### Battery Replacement Procedure for Q17nDCPU(-S1)

Thank you for your continued patronage of the Mitsubishi servo system controller and FA products. The recommended battery replacement procedure for Q17nDCPU(-S1) has been changed. For the details, refer to the following.

Figure 1: Battery replacement procedure

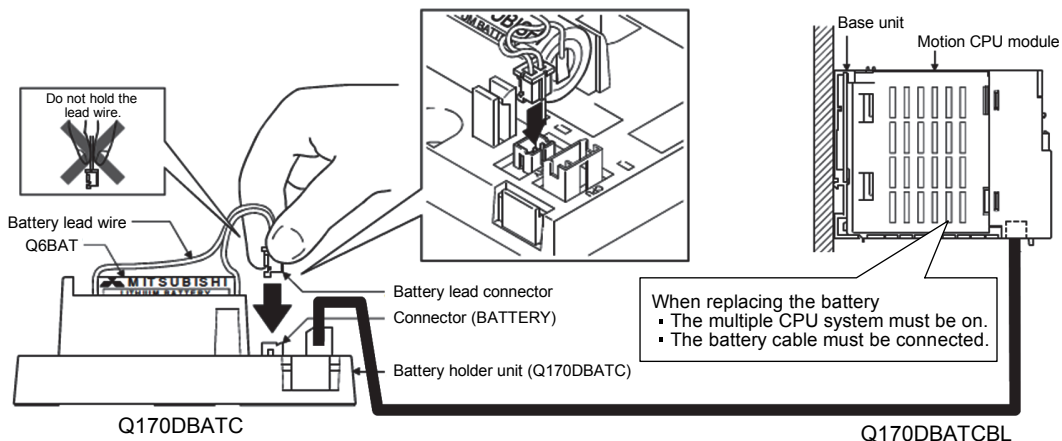
For the motion CPU module that operates for a long time, replacing its battery while the module power is off may lose the backup data. To avoid such a problem, we recommend a different procedure.

(1) Replace the battery (Q6BAT) while the motion CPU module is on. (Do not turn off the module.)

(2) When the battery is removed, a battery error occurs. ("BT2" lights up on the 7-segment LED display.) After replacing the battery, perform one of the following operations to remove the error.

- (a) Cycle the power or perform the reset operation.
- (b) Turn off the Motion error detection flag (M2039).
